HECTOR ZAMMIT ARCHITECT CIVIL ENGINEER DESIGN CONSULTANT	THE CORNERSTONE 224, TRIQ SAN GILJAN BIRKIRKARA BKR 2807. Tel: 21446777	Rev.:	Date:	By:	Description:	Address: Kappella Santa Marija Pjazza Santa Marija, Zejtun Client: Fr. Nicholas Pace	Project Title: Reconstruct of dangerous roof using same method & material of original constr. & reinf. of weaker southern wall by introducing stone buttresses Scale: 1:100 Ckd.: HZ Drawn By: DD Drawing No.: 08 Date: 07.08.17		Drawing Title: Sections A-A, B-B, C-C, D-D & E-E File No.: 1454/16

PROPOSED SECTION A-A
Scale:- 1:100

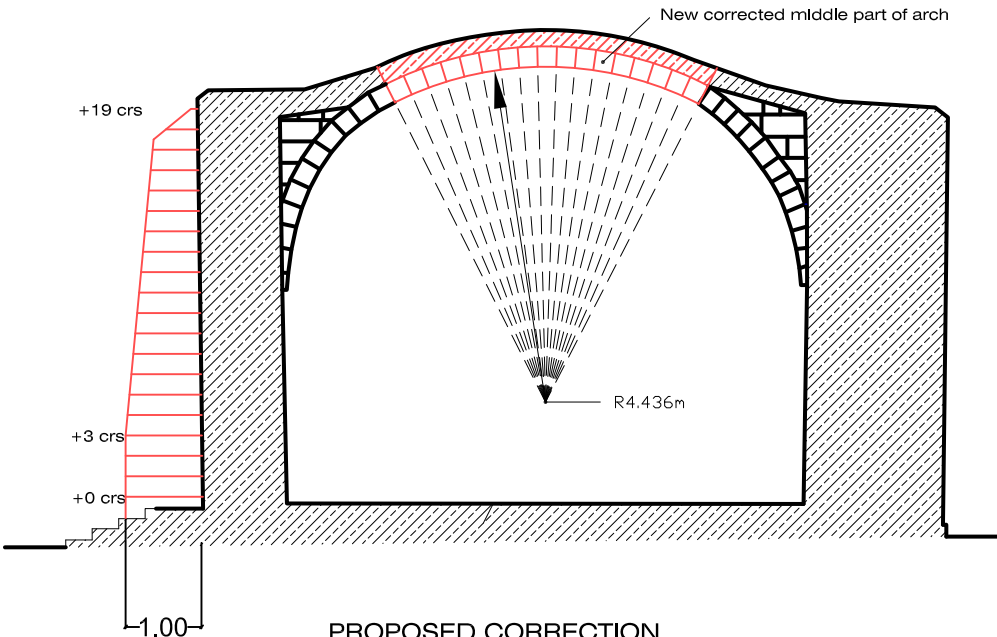
PROPOSED CORRECTION
TO DISTORED ARCH ON SECTION A-A

PROPOSED SECTION B-B
Scale:- 1:100

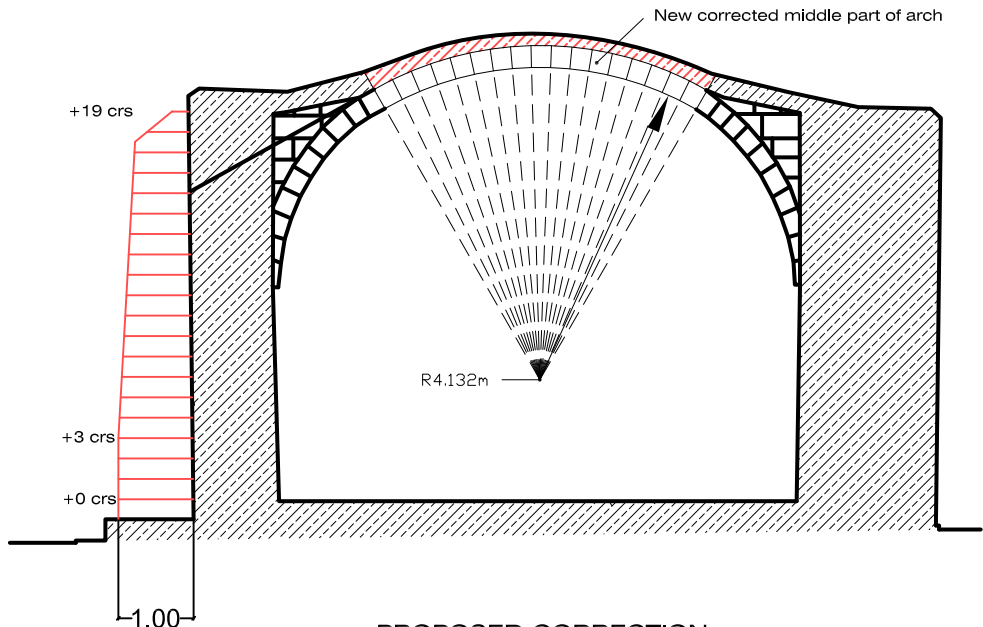
PROPOSED CORRECTION
TO DISTORED ARCH ON SECTION B-B

PROPOSED SECTION C-C
Scale:- 1:100

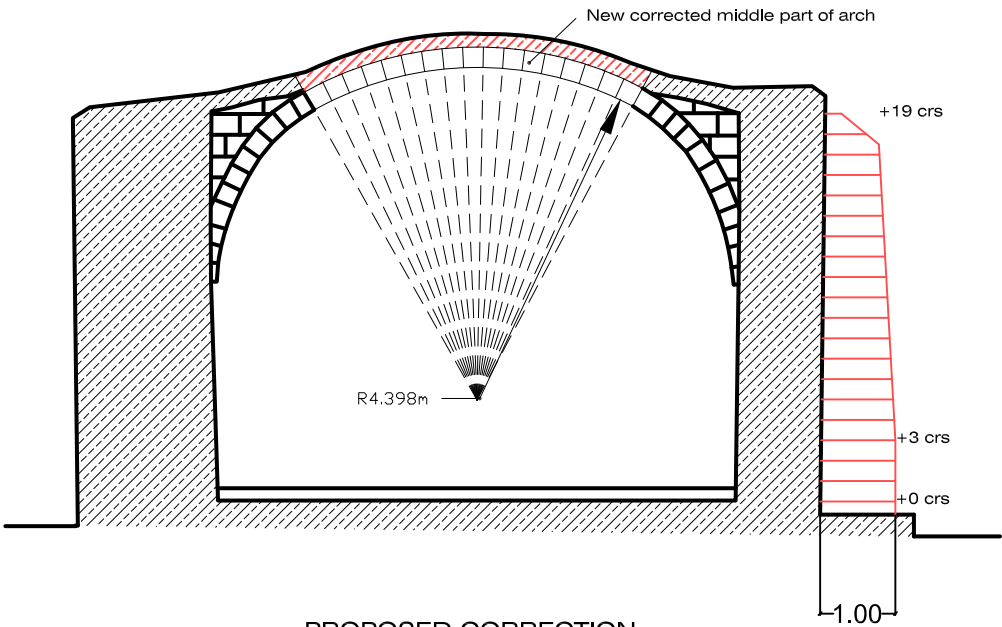
PROPOSED CORRECTION
TO DISTORED ARCH ON SECTION C-C

PROPOSED SECTION D-D
Scale:- 1:100

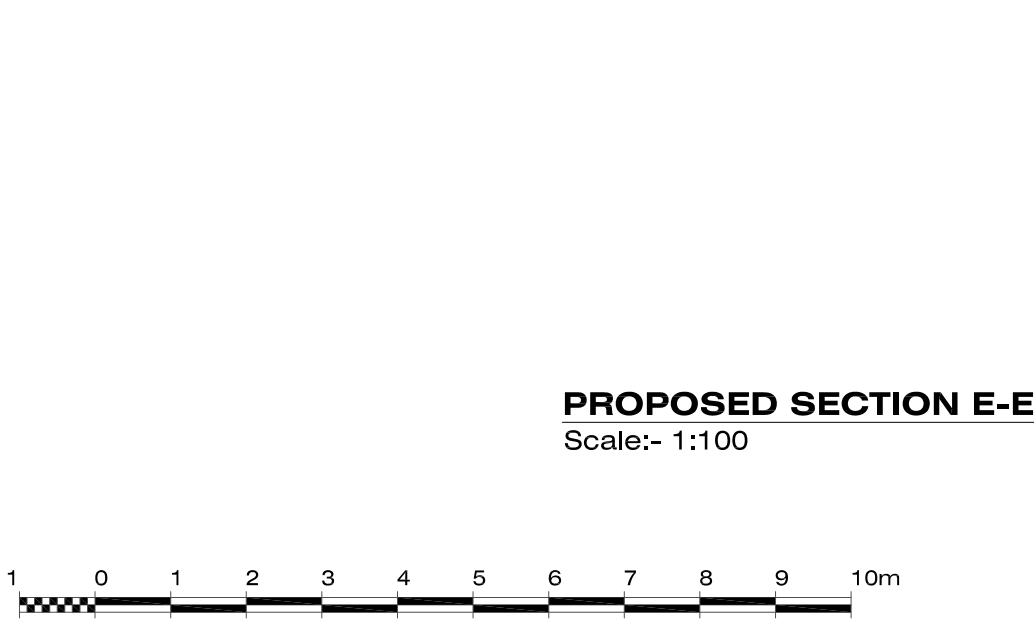
PROPOSED CORRECTION
TO DISTORED ARCH ON SECTION D-D
